From: Jade McRae <Jade.McRae@es.govt.nz>
Sent: Tuesday, 21 July 2020 4:04 PM
To: Claire Perkins <Claire@landpro.co.nz>
Cc: rsharma@goredc.govt.nz; Planning <Planning@goredc.govt.nz>
Subject: Request for further information on resource consent application - s92(1) - APP-20202268

Landpro Reference: 20012

Council Reference: APP-20202268

**Re: Request for Further Information under Section 92(1) of the Resource Management Act 1991 –
Application for Longford Bridge Shared Pathway.**

Figure 1: Abutment shelf and beam soffit levels

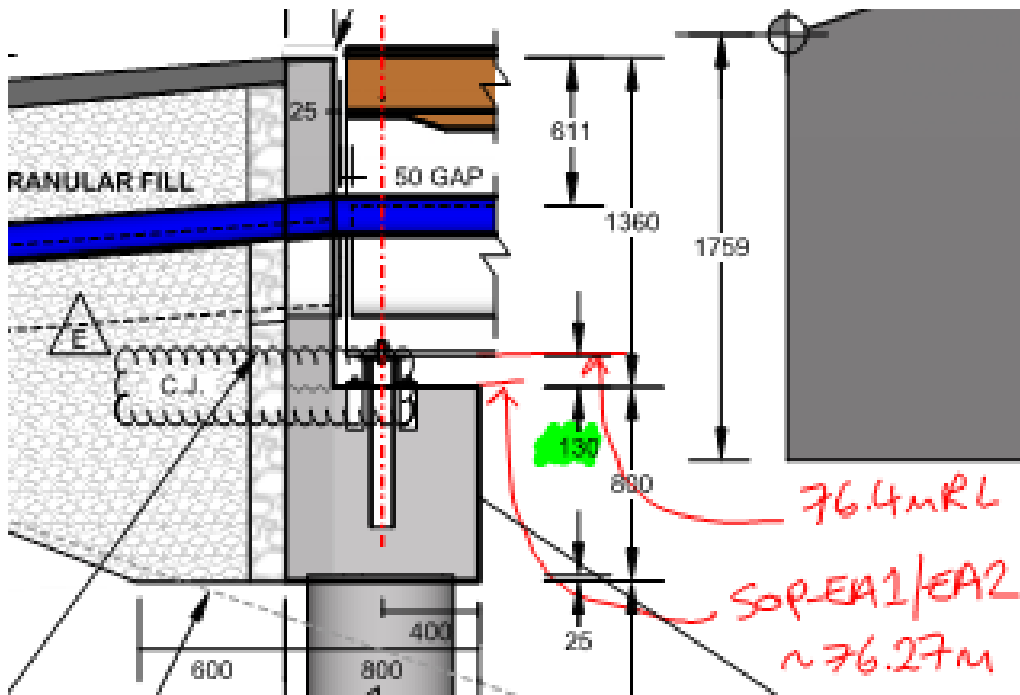
"Confirmation of the eastern abutment construction level. The design diagram shows the soffit at a level of 76.4m (plan S101), but the abutment set out plan shows a level 76.269m (SOP-EA1) plan S111. I am requesting this information because Council's Engineer has some concerns relating to the inconsistent construction levels of the eastern abutment."

The abutment shelf level on S111 is not the same thing as the beam soffit level as shown on S101. Between these two levels is the abutment bearing of circa 130mm (see Figure 1 below). This is not an inconsistency.
